VIRGINIA ELECTRIC AND POWER COMPANY (DOMINION)
NORTH ANNA POWER STATION UNITS 1 AND 2
RESPONSE TO REQUEST FOR ADDITIONAL INFORMATION
PROPOSED TECHNICAL SPECIFICATION CHANGE AND
SUPPORTING SAFETY ANALYSES REVISIONS TO ADDRESS
GENERIC SAFETY ISSUE 191

RESPONSE TO REQUEST FOR ADDITIONAL INFORMATION

REQUEST FOR ADDITIONAL INFORMATION
REGARDING GENERIC SAFETY ISSUE 191
TECHNICAL SPECIFICATION AMENDMENT
NORTH ANNA POWER STATION UNIT NOS. 1 AND 2

Figure 1: GOTHIC Containment Temperatures and Composite Profile for EQ

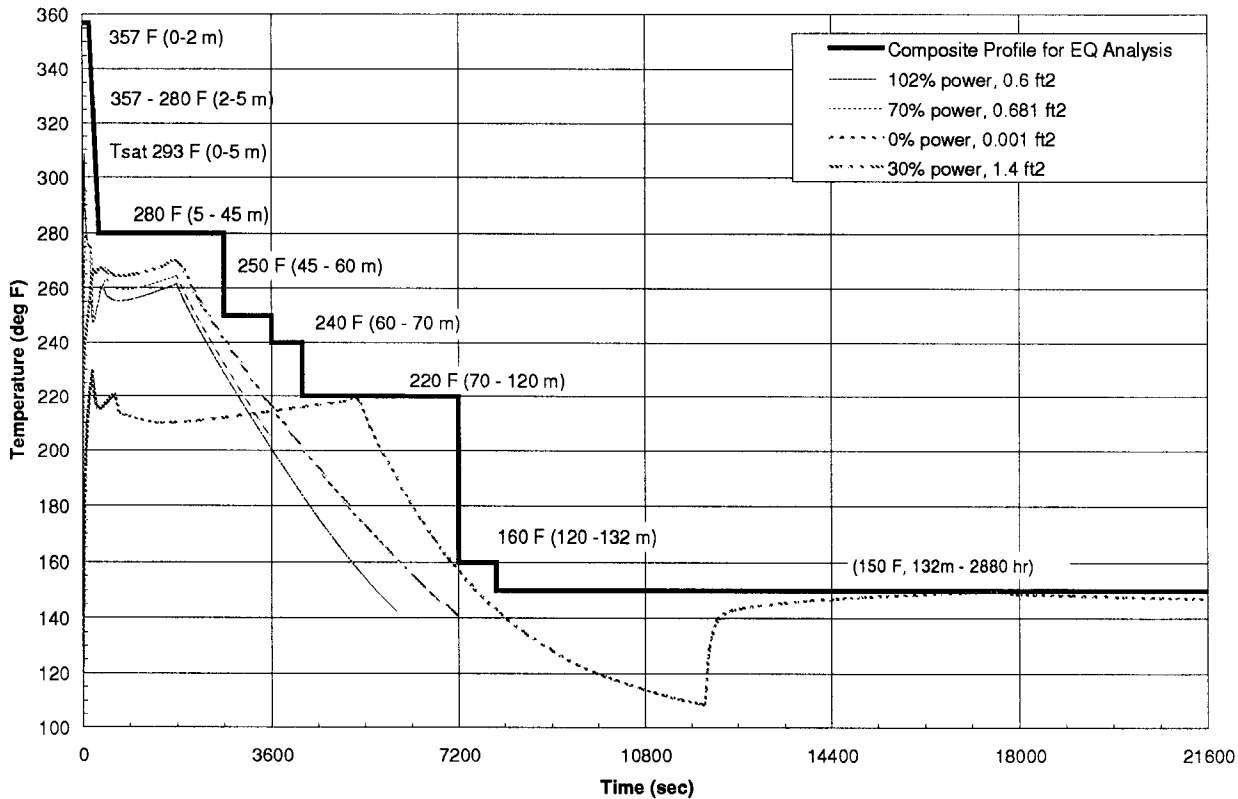
Attachment 1, Section 3.9, fourth sentence states: "Composite pressure and temperature profiles were developed that bounded the [loss-of-coolant accident] LOCA and [main steam line break] MSLB pressure and temperature profiles from GOTHIC." Please provide the developed composite pressure and temperature profiles which are the revised basis for equipment qualification.

Figures 1 and 2 compare GOTHIC containment vapor temperature and pressure profiles for the most limiting MSLB analyses to the equipment qualification (EQ) composite profiles that were developed to bound all GOTHIC results for LOCA and MSLB analyses. The MSLB accident produces long-term containment temperature and pressure profiles that bound the LOCA event, because the MSLB analyses do not credit the recirculation spray (RS) system and assume only one quench spray (QS) pump is available for containment atmosphere cooling. Thus, the MSLB long-term pressures and temperatures are more severe than LOCA analyses that assume one QS pump and two RS pumps. Figures 1 and 2 compare the most limiting MSLB profiles and the effect of not crediting the RS system in the MSLB analysis is evident. The most adverse long-term temperature is obtained for a 0.001 ft² MSLB at 0% power. This small break size has a significant amount of steam generator (SG) liquid mass remaining when auxiliary feedwater is terminated at 30 minutes. The SG secondary boiloff continues until 5,270 seconds, at which time containment pressure and temperature begin to decrease. When QS spray is terminated at about 12,000 seconds, there is no active containment heat removal and the containment temperature increases to a peak that is less than 150°F. In the long-term, the containment temperature decreases as energy is transferred through the containment walls to the outside atmosphere.

The EQ composite profiles in Figures 1 and 2 were compared to the test reports for all environmentally qualified equipment inside containment, and it was concluded that the environmentally qualified equipment inside containment remain qualified for the GOTHIC accident analysis profiles for pressure and temperature.
